TECHNICAL REVIEW COMMITTEE Development Project Report

Date Issued:	November 12, 2019
Project Name:	DSV #19-03, Front Street Village
Applicant:	Don and Sally Korthuis
Property Owner:	Don and Sally Korthuis
Site Address:	2111 W Front Street
Zoning Designation:	CSR (Regional Commercial Services)
Application Type:	Development Standards Variance
Parcel Size:	N/A
Hearing Type:	Quasi-Judicial
Hearing Objective:	The objective of this public hearing is to determine whether the proposed Development Standards Variance meets the criteria found within Section 17.17.040 of the Lynden Municipal Code.
Date application determined complete:	October 31, 2019
Date of Publication:	November 6, 2019
SEPA Determination:	N/A
Project Description:	Applicant is requesting a Development Standards Variance to allow the construction of an arterial street at 60-feet from the required 80-feet.

Front Street Station
Don and Sally Korthuis
Version 3
10/30/19

EXHIBIT E Proposed right of way FSS Development Agreement

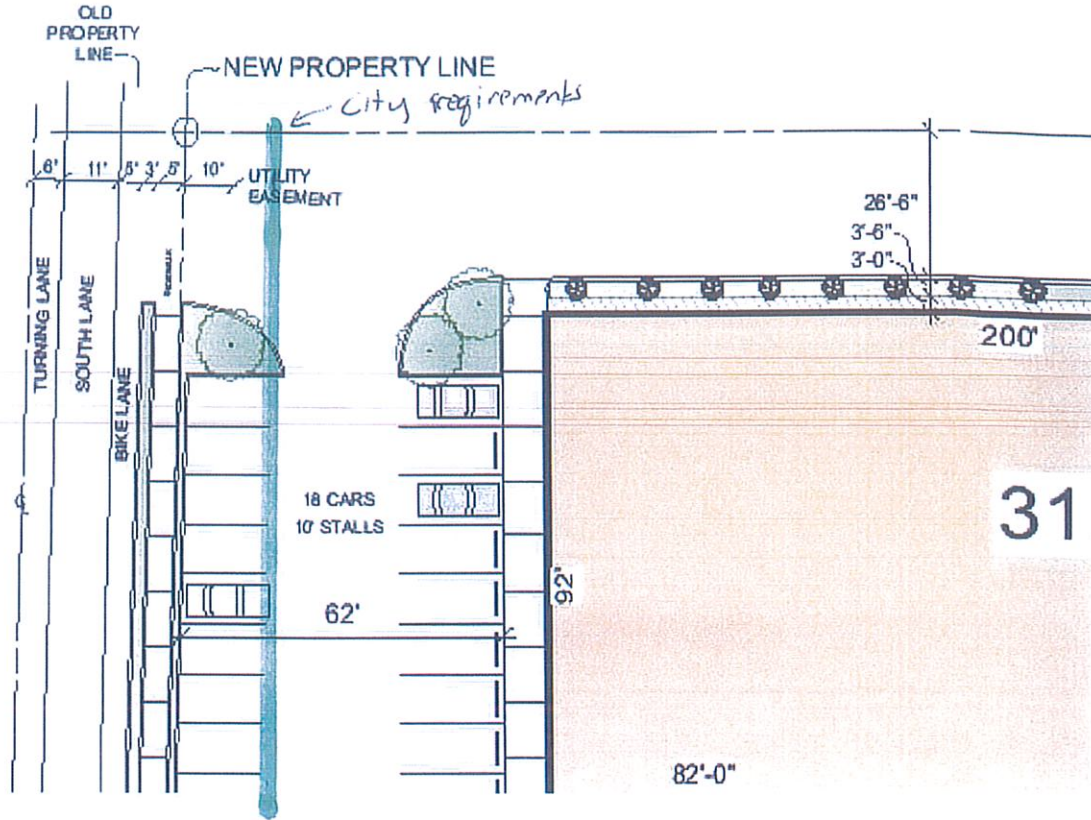
The variance proposal we are requesting is to have the 20' dedicated easement be reduced to 10' dedicated easement. In addition to this dedicated easement, we will give an additional 10' of a utility easement. With 10' of dedicated easement, and by shifting the roadside trees into the parking lot islands, the city will get the function it is looking for. See the enclosed Exhibit E Proposed right of way for detail. The city requires, moving from North to South:

1. A center turn lane, 6' on each side of the center line of West Front Street. That works for us.
2. An 11 foot South lane (West bound traffic). That works for us.
3. A 5' bike lane. That works for us.
4. A 5-8' landscape green buffer. The purpose of this large buffer is twofold. One, people on the sidewalk don't like to walk near busy traffic, and any green buffer gives them a feeling of safety. Secondly, the green buffer has been widened lately, so that the required landscape tree roots don't interfere with the sidewalk, curb, gutter and bike lane.
5. 5' of sidewalk. That works for us.

1. The previous items, 1, 2, 3 listed above are left alone.
2. The green buffer in number 4 above will be both split up and elongated. Split up into a 3' section adjacent to the bike lane and the sidewalk, and a second green area, "car bumper area" of 2', adjacent to the property line and the sidewalk.

3. The landscape trees, up on the street, can be visual barrier to the view of a passing motorist, to see the development and address numbers clearly. To deal with the landscape trees, we propose making south-facing, elongated island landscape areas every 50' in the parking lot.

1. *Variance Justification:* The applicant has provided a response to each of the development standards variance criteria. See attached
2. *Alternate Design Analysis:* The applicant has provided a response to each of the development standards variance criteria. See attached
3. *Street Trees:* Required street trees to be established on private property along the West Front Street frontage. A corresponding development agreement will require perpetual maintenance of the trees by the property owner.

FIGURE
4-2

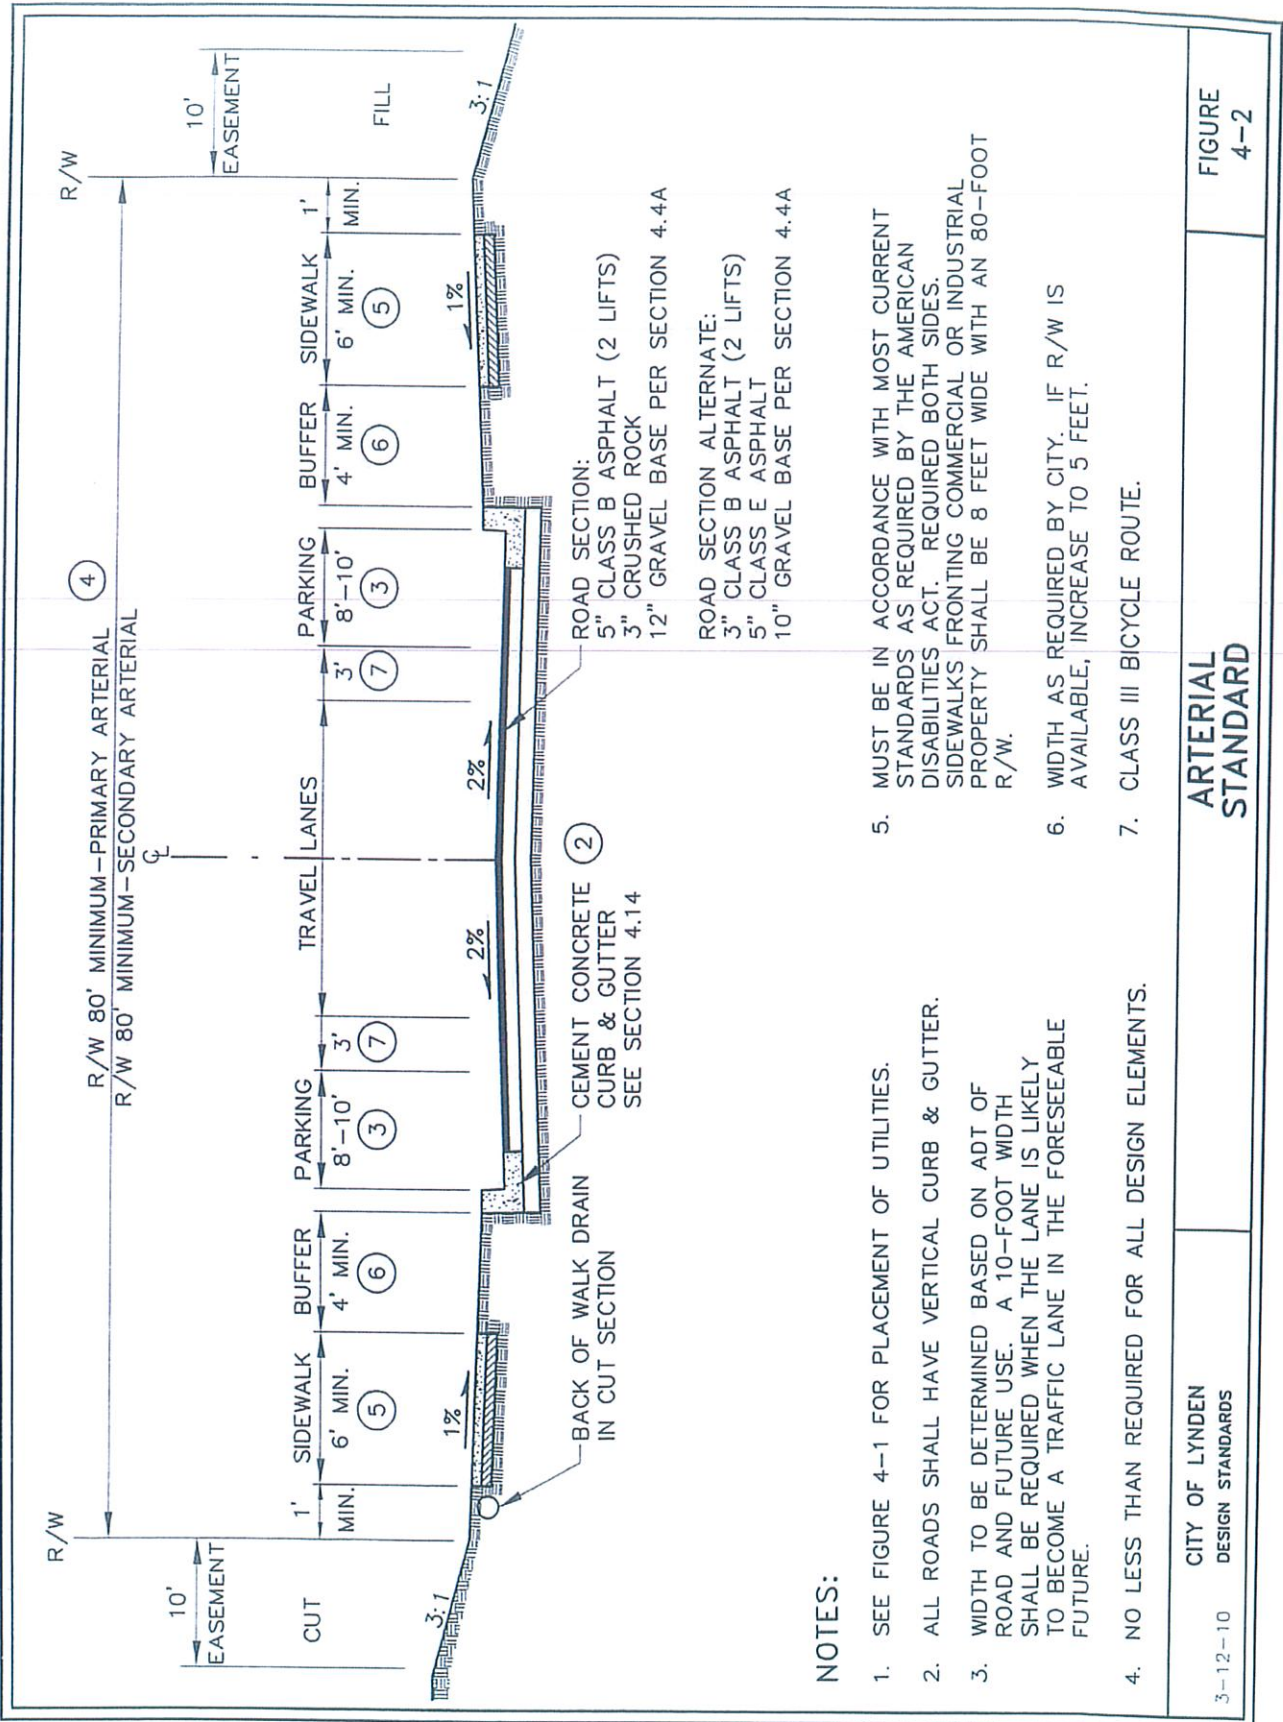
The applicant is requesting a variance to LMC 18.14.030 which requires property dedication for rights-of-way and Table 4-1 (Figure 4-2) of the Engineering Design and Development Standards to allow the construction of an arterial street from the required 80-feet to 60-feet. The variance would reduce the required property dedication from 20 feet in width to 10 feet. The proposed project is located on approximately 7 acres of vacant property and would affect approximately 475-feet of frontage along West Front Street.

A 30-foot ROW abutting Front Street Station allows construction of a 44-foot wide paved street cross-section matching the improved street to the east but reduces sidewalk width from 8-feet to 5-feet, with a small 3-foot planter strip between, and street trees shifted into parking islands on the property.
